Access Compliance Report

(Curb Ramps)

Intersection ID: 48416	Main Street: YORK_CROSSING_DR	Cross Street: S_TRYON_ST	Location: SE
ADA ID: 8C7F9D0F0E6F	Ramp Type: Perp	Initial Pass/Fail: Fail	Overall Compliance: No
Codes/Mitigation Info/Possible Solution		Field Measurements/Component Compliance	
Severity Score: 46.25

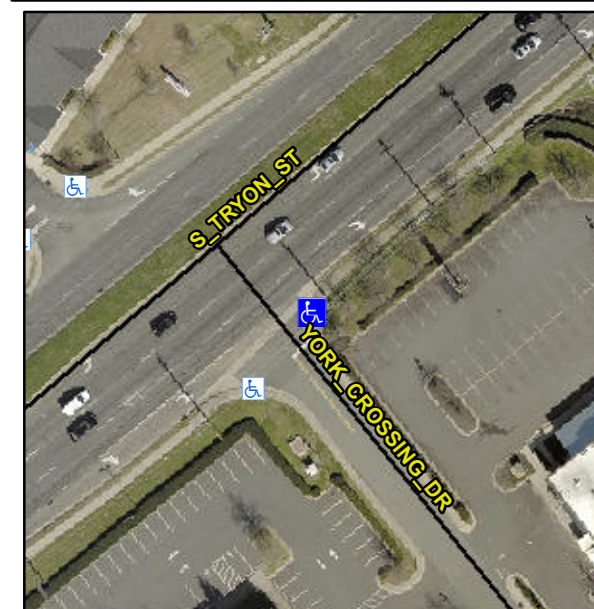
R304.5.1, R304.2.2, R304.5.3

Compliance	Description	Data	Compliance	Description	Data
N/A	Ramp Length (in)	49.0	No	Ramp Slope (%)	12.9
No	Ramp Width (in)	46.0	No	Ramp XSlope (%)	5.8
N/A	Flare Type LT	N/A	N/A	Flare Type RT	N/A
N/A	Flare Slope LT (%)	N/A	N/A	Flare Slope RT (%)	N/A
N/A	Flare Traversable LT?	N/A	N/A	Flare Traversable RT?	N/A
N/A	Landing Length (in)	N/A	N/A	DWS Provided?	N/A
N/A	Landing Width (in)	N/A	N/A	DWS Contrast?	N/A
N/A	Landing Slope (%)	N/A	N/A	DWS Length (in)	N/A
N/A	Landing X Slope (%)	N/A	N/A	DWS Full Width?	N/A
N/A	Landing Curb? (Y/N)	N/A	N/A	DWS Offset (in)	N/A
N/A	Shared Landing?	N/A			
N/A	Gutter Ponding?	N/A	N/A	Gutter Slope (%)	N/A
N/A	Gutter Lip Ht (in)	N/A	N/A	Gutter X Slope (%)	N/A
N/A	Painted X Walk1?	No	N/A	Painted X Walk2?	N/A
	X Walk 1 Direction	To SW		X Walk 2 Direction	N/A
N/A	X Walk 1 Width (in)	N/A	N/A	X Walk 2 Width (in)	N/A
	X Walk 1 Slope (%)	0.4		X Walk 2 Slope (%)	N/A
	X Walk 1 X Slope (%)	6.0		X Walk 2 X Slope (%)	N/A

Remove & Replace Entire Ramp.
